To: T10 Committee (SCSI)

From: George Penokie (LSI)

Subject: SAS-2: Making 07-267 into an Annex

This is the re-creation of 07-267r1 putting it into a form that can be placed into the SAS-2 standard as an informative annex.

Figure 1 — Reference receiver device

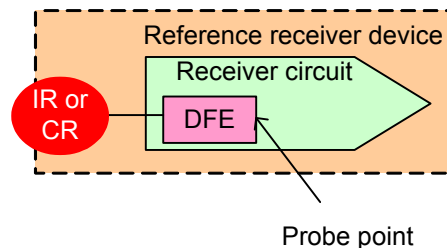
The reference receiver device includes a 3 tap decision feedback equalizer (DFE) with infinite precision taps and unit interval tap spacing. The reference coefficient adaptation algorithm is the least mean square (LMS) algorithm. The DFE may be modeled at the center of the eye as:

The reference receiver assumes the ~~equalizer~~equalizer feedback coefficients (i.e., d_i) are positive and their magnitudes are less than 0.5.

Figure A.1 — S-parameters modeling circuits for simulation

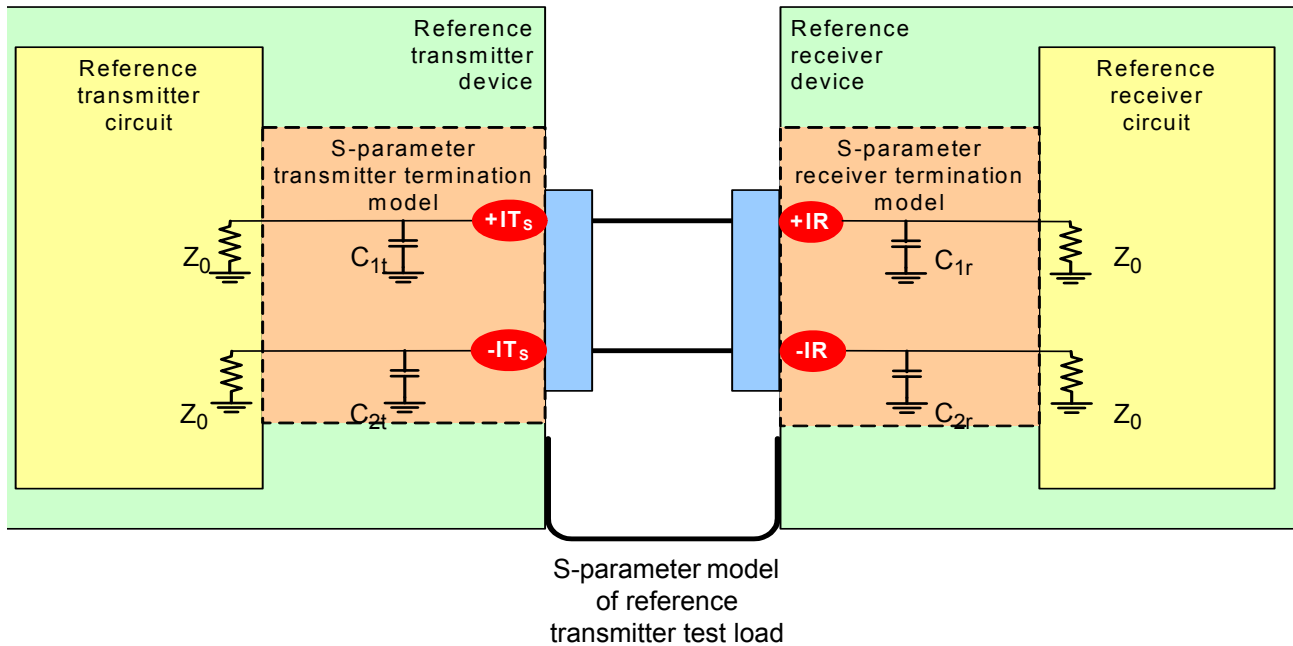
The S-parameters are able to be simulated using simple circuits to represent:

- a) a reference transmitter termination (see figure A.1);
- b) a reference receiver termination (see figure A.1); and
- c) the return loss (see figure A.4).

Figure A.2 — Results of simulated S-parameter Tx/Rx termination model

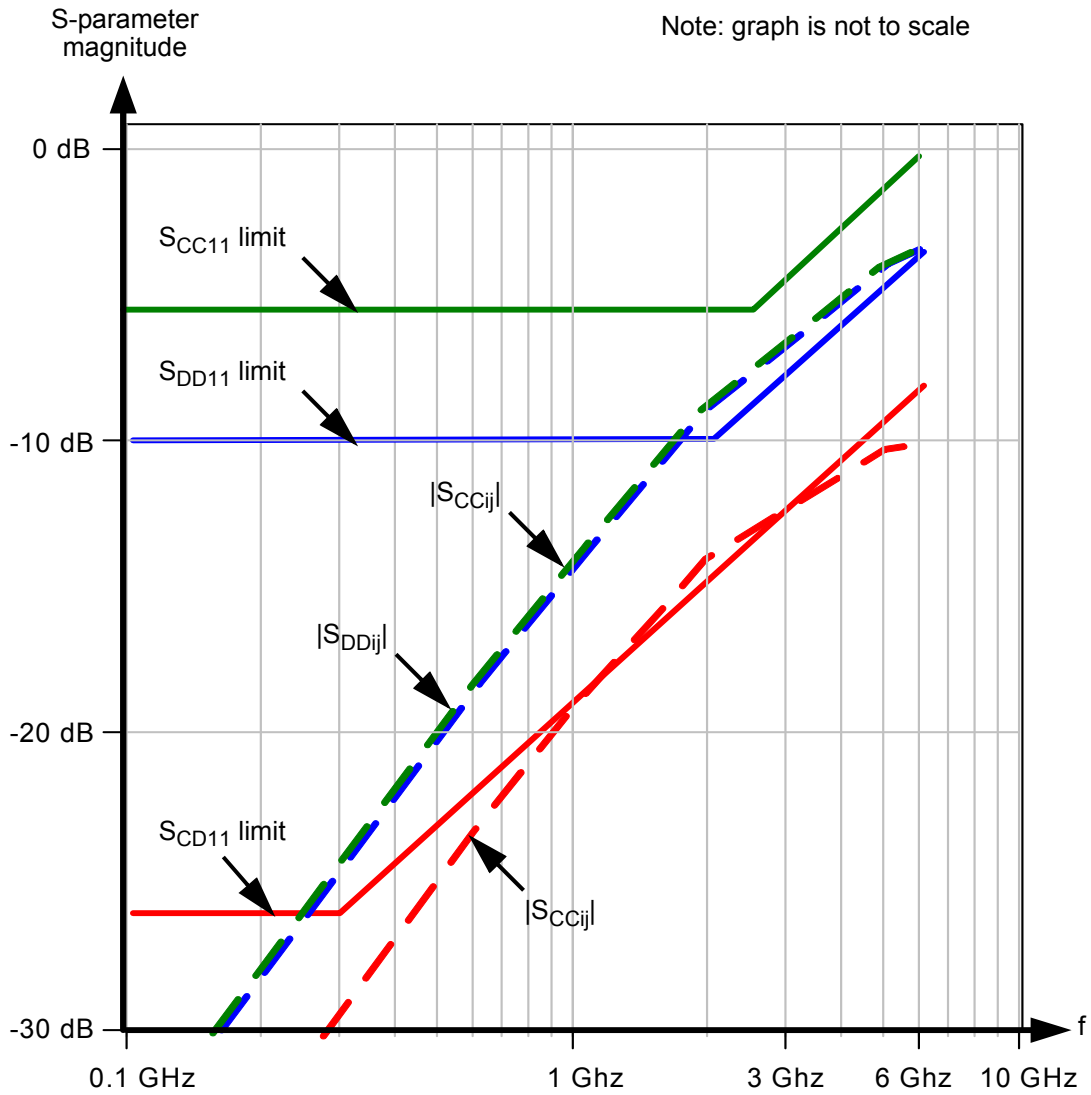
By setting C_{1t} to 0.5 pf τ_1 becomes 12.5 ps and C_{2t} to 2 pf τ_2 becomes 50 ps in these equations a model of the S-parameters for the transmitter termination may be generated (see figure A.2).

By setting C_{1r} to 2 pf τ_1 becomes 50ps and C_{2r} to 0.5 pf τ_2 becomes 12.5 ps in these equations a model of the S-parameters for the receiver termination may be generated (see figure A.2).
